BENSALEM TOWNSHIP

Township of Bensalem, Bucks County, Pennsylvania Notice of Appeal

Project:	RENOVATIONS/2nd FLR ADDITION
Project Address:	3924 BENSLEM BLVD BENSLEM, PA 19020
Tax Parcel:	02-076-018
Property Owner:	MICHAEL J. MCCUE
Permit Status:	APPLICATION DENIED

Electronic Review Status

SITE PLAN

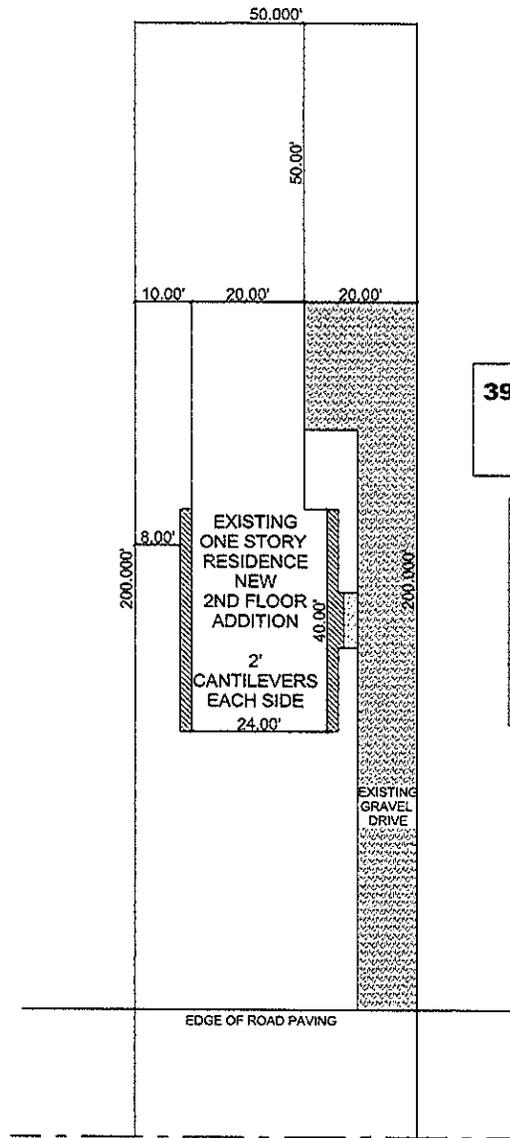
Author: rgans Subject: Text Box Date: 3/3/2016 10:42:55 AM
 The proposed side yard of 8 feet is less than required 12 feet.
 [Section 232-153(e)(2)a.]
